HOWELL TOWNSHIP PLANNING COMMISSION REGULAR MEETING 3525 Byron Road

Site Plan Review For Howell Township, Michigan

Applicant:	Old Glory LLC
Project Name:	Parking Lot Addition
Plan Date:	January 25, 2024
Location:	4120 W Grand River Ave
Zoning:	Regional Service Commercial District (RSC)
Action Requested:	Preliminary Site Plan Approval

RE: Old Glory Car Wash 4120 Grand River Avenue, Howell Township Preliminary Site Plan Review

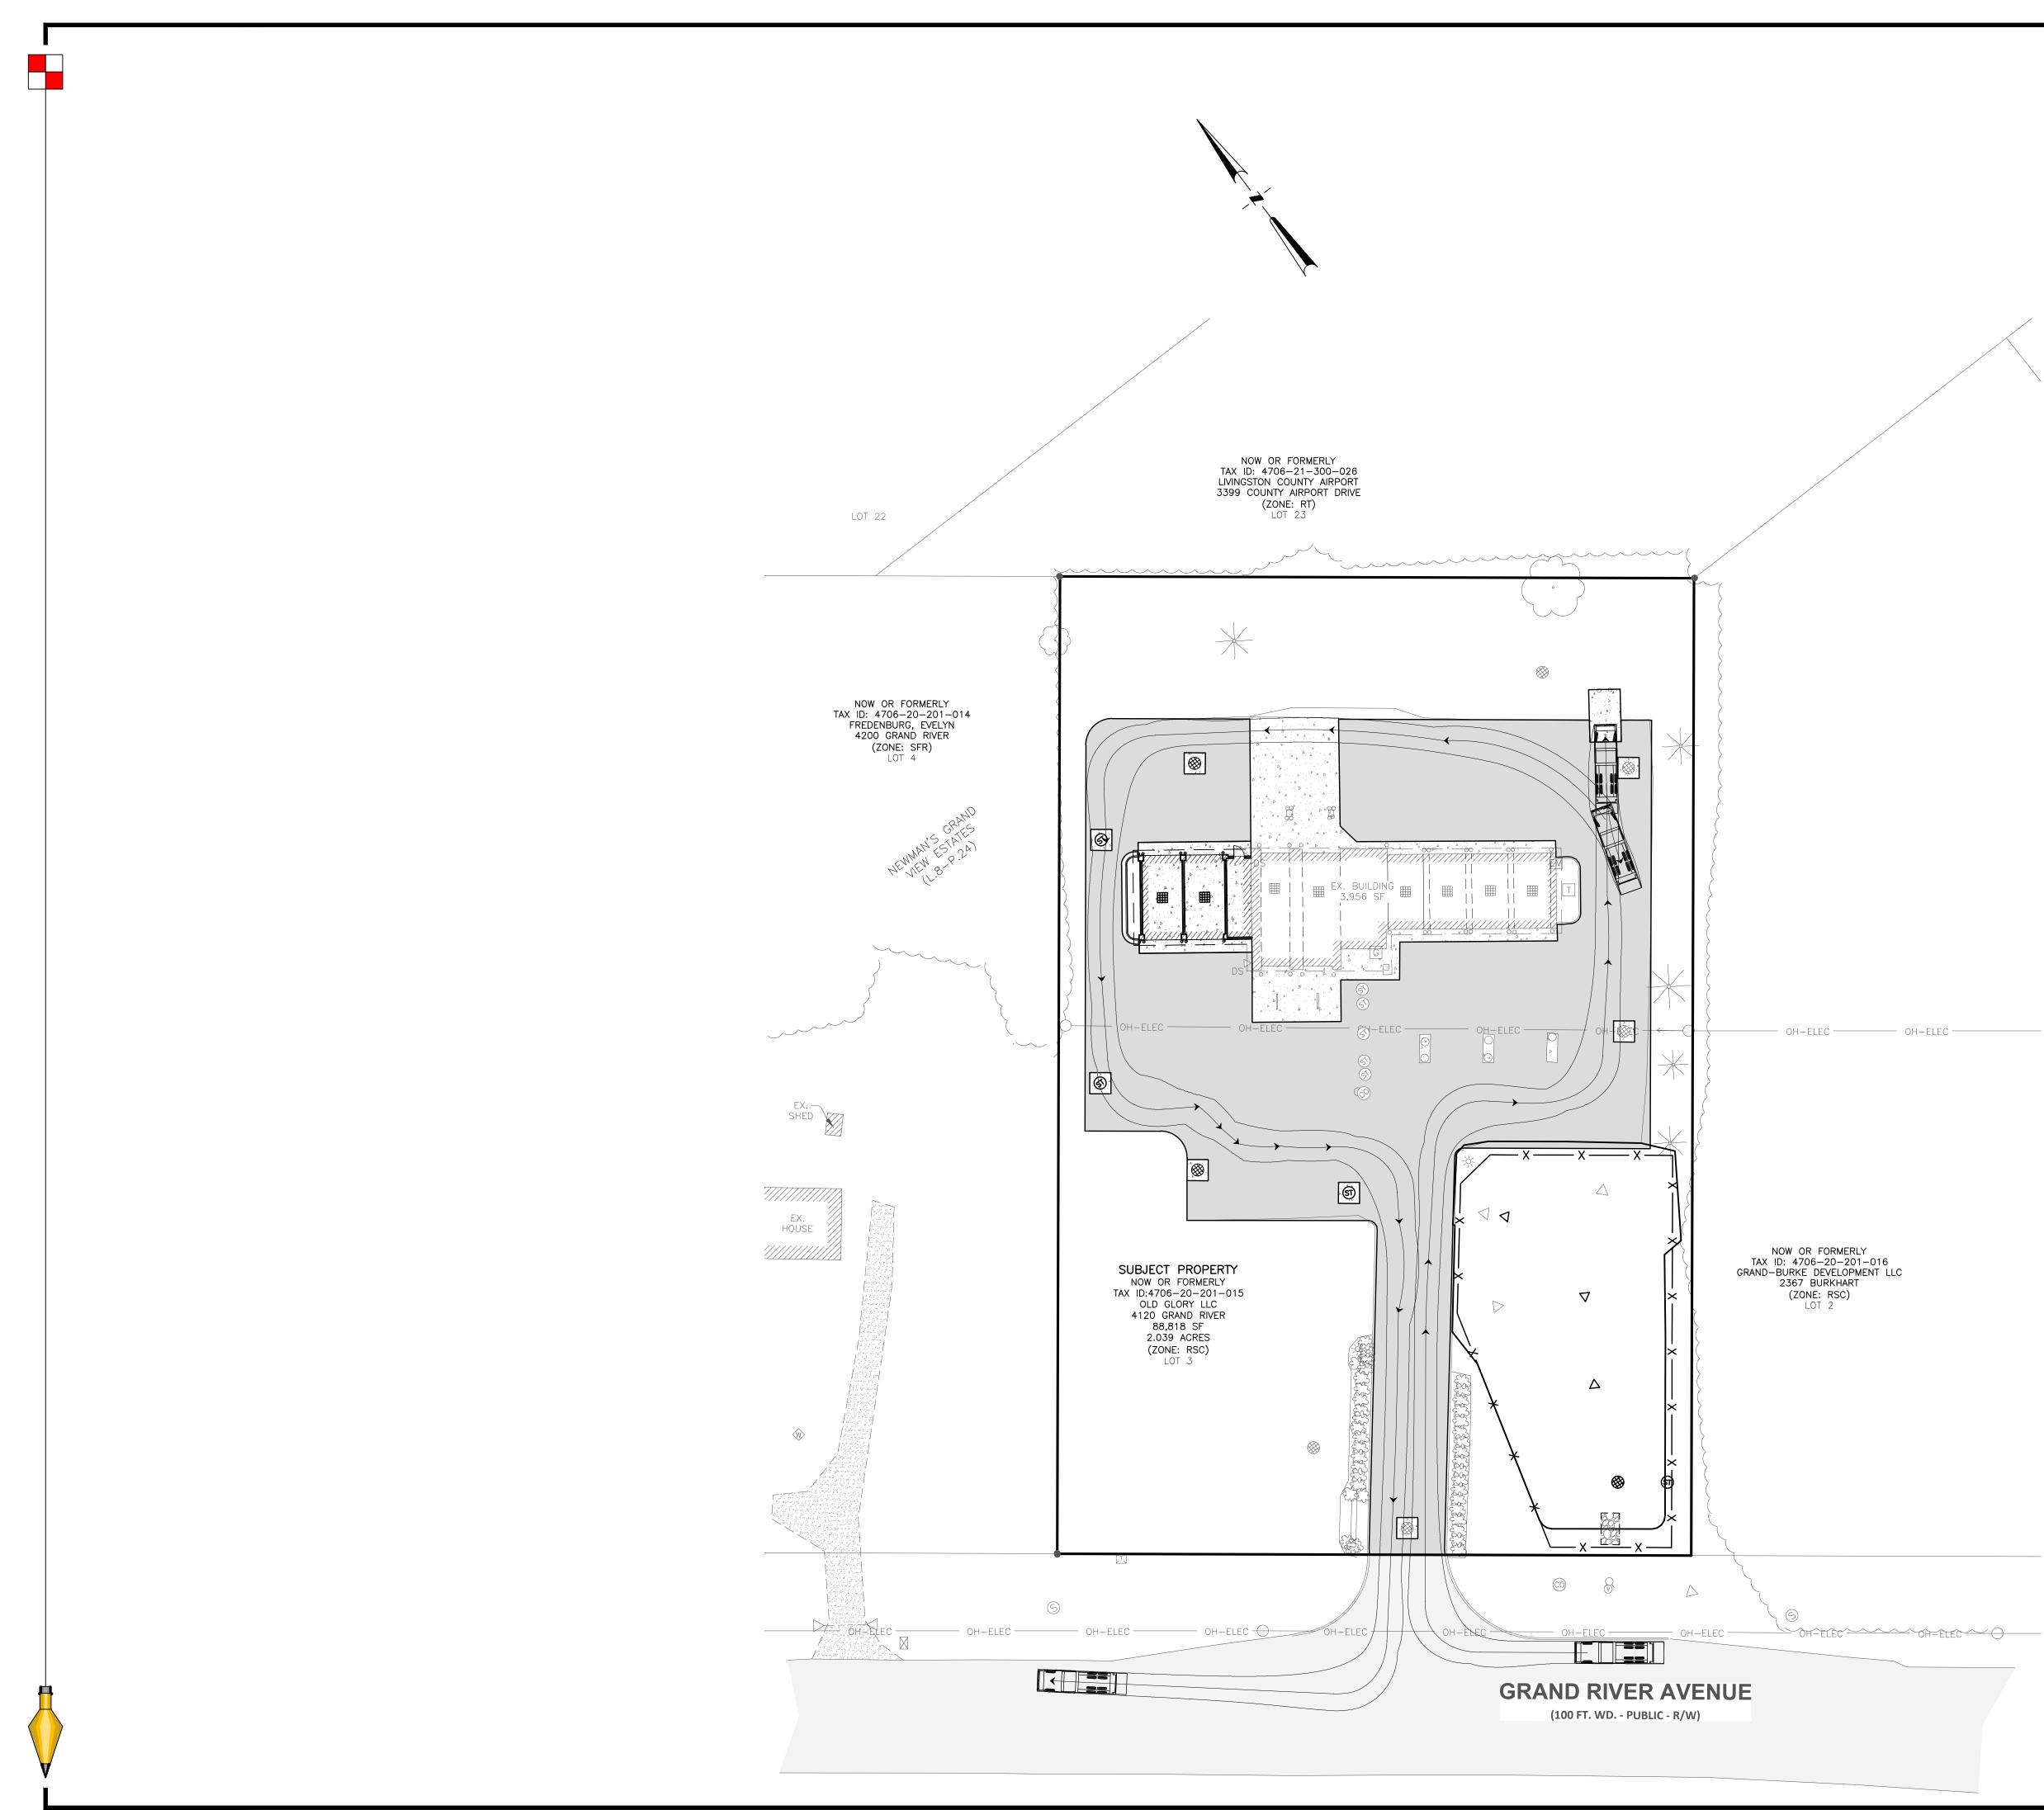
The applicant provides a refuse vehicle circulation and emergency vehicle circulation plan which demonstrate proper vehicular traffic flow.
